Monticello Nuclear Generating Plant
2807 W County Road 75
Monticello, MN 55362

Response to Second Request for Additional Information for the License Amendment
Request to Revise the Minimum Critical Power Ratio Safety Limit in Reactor Core
Safety Limit 2.1.1.2 (TAC No. ME4790)

**RESPONSE TO SECOND REQUEST FOR ADDITIONAL INFORMATION FOR THE
LICENSE AMENDMENT REQUEST TO REVISE THE MINIMUM CRITICAL POWER
RATIO SAFETY LIMIT IN REACTOR CORE SAFETY LIMIT 2.1.1.2**

**Figure 5
Monticello Cycle 26 Power/Flow Map**

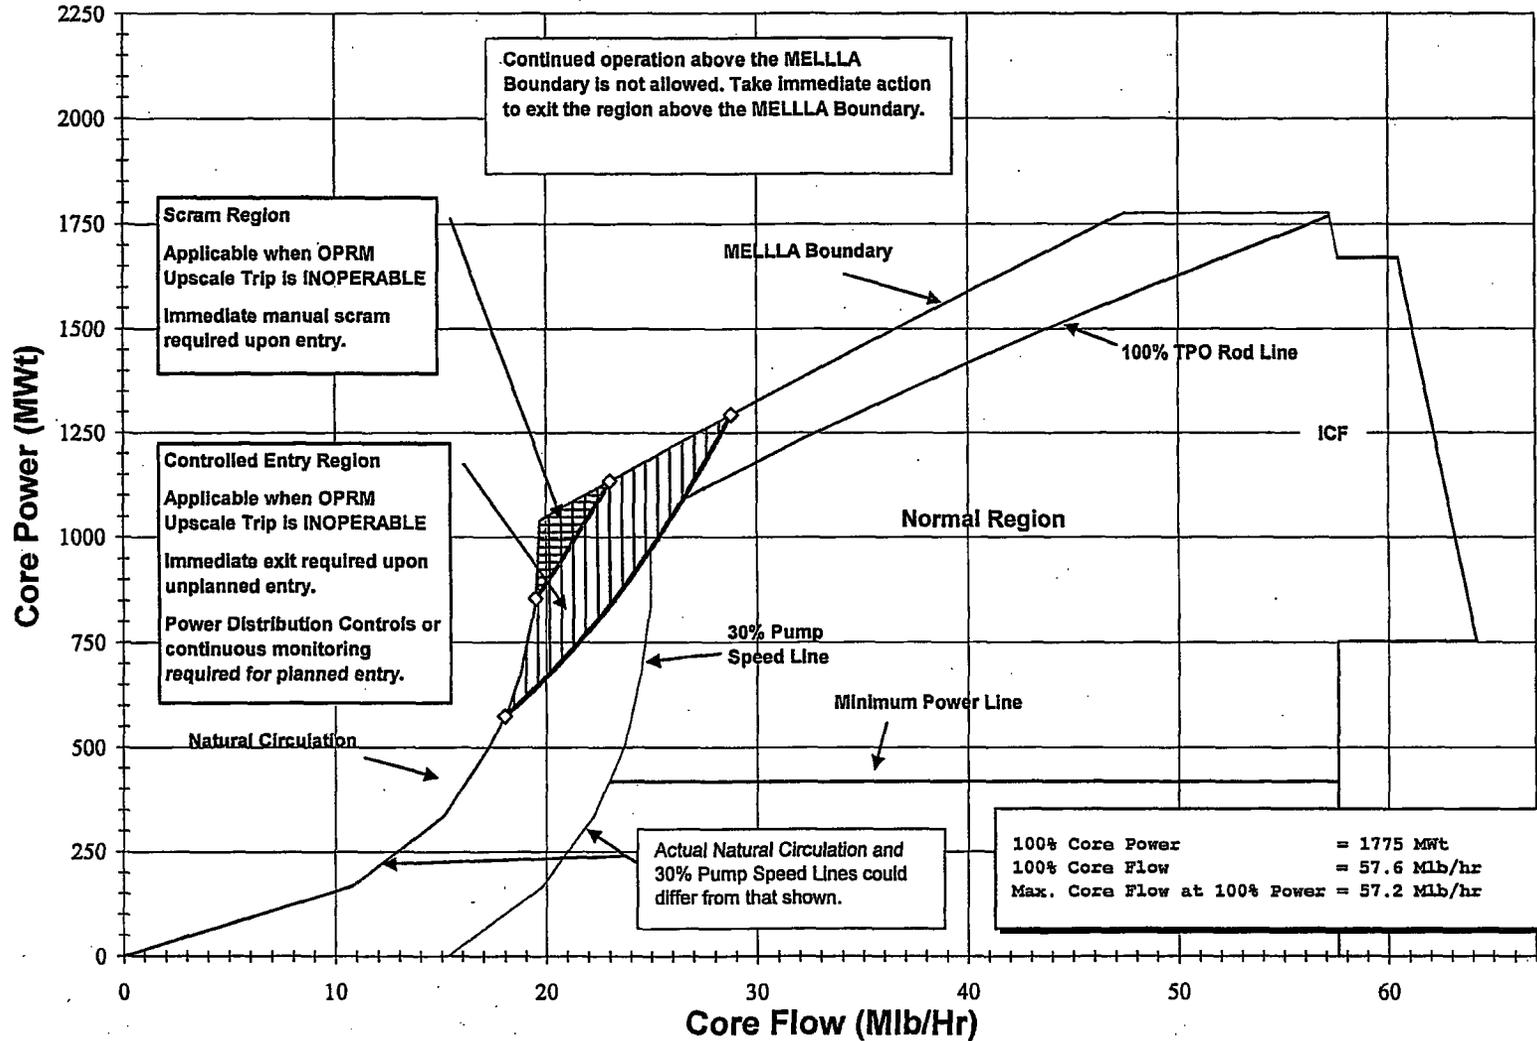
(2) no GE14 fuel data in Figure 5 of the September 17, 2010, submittal.

Please provide the most up-to-date version of Figure 5 that was included in Enclosure 6 of the September 17, 2010, License Amendment Request, that includes the GE14 fuel data.

The redacted figure is indicated below.

Figure 1.1-1 Licensed Power/Flow Operating Map

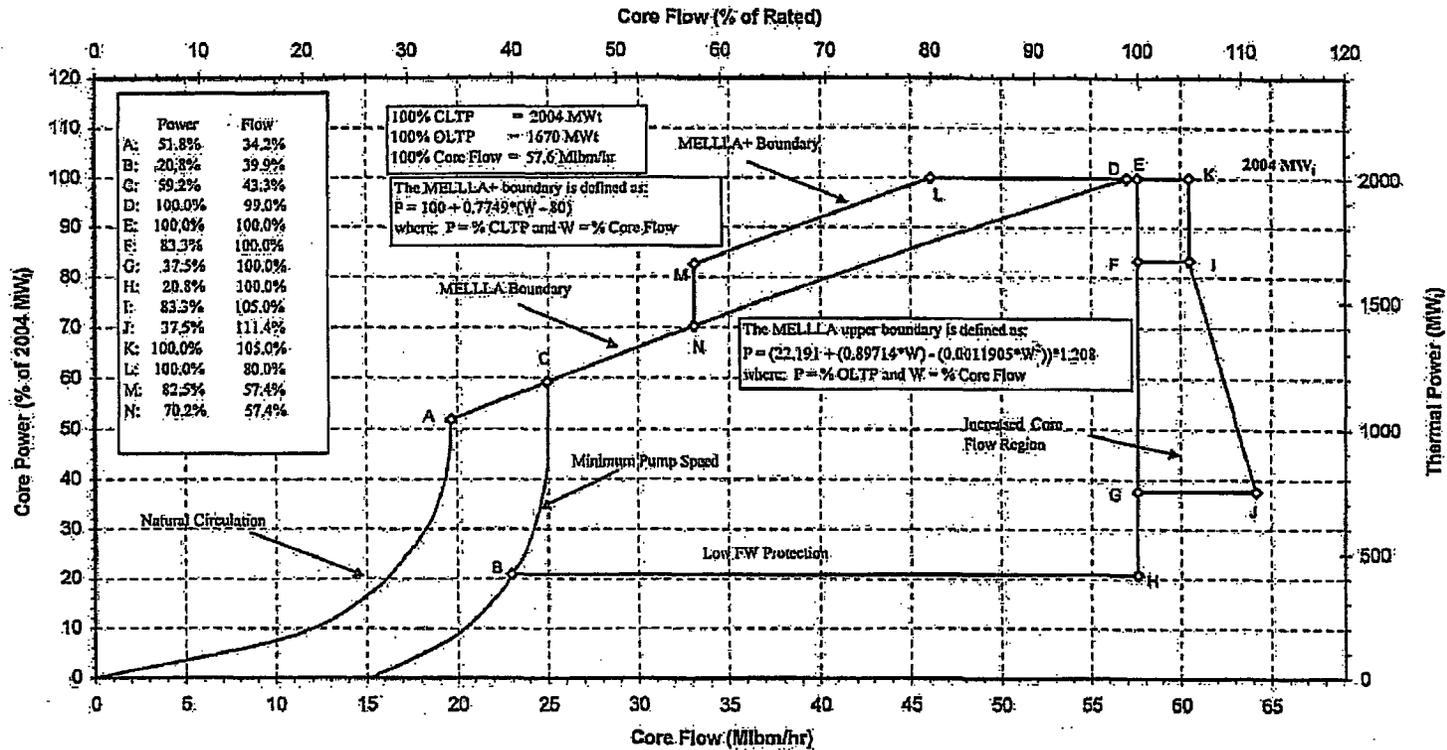
- (1) **power/flow map not provided in response to Q7** (Question 7 in the February 8, 2011, RAI response (Reference 3)).

During discussion between the NRC reviewer and NSPM / GNF personnel during the April 12, 2011, conference call it was recognized that what would be most useful for the reviewer were copies of the Cycle 26 Maximum Extended Load Line Limit Analysis (MELLLA) and Maximum Extended Load Line Limit Analysis – Plus (MELLLA+) power/flow maps. Copies of these power/flow maps are provided immediately behind this enclosure. The first power/flow map is from the proposed MNGP Cycle 26 Core Operating Limits Report (COLR) for MELLLA operation (at the current licensed thermal power level of 1775 MWth) and is labeled, “Figure 5 – Monticello Cycle 26 Power/Flow Map.” The second power/flow map is from the Operating Parameters List (OPL-3), a design input from NSPM to GNF. This power/flow map is for Cycle 26 operation assuming Extended Power Uprate (EPU) operation is approved (licensed thermal power level of 2004 MWth) and shows both the MELLLA and MELLLA+ boundaries, and is labeled “Figure 1.1-1 – Licensed Power/Flow Operating Map.”
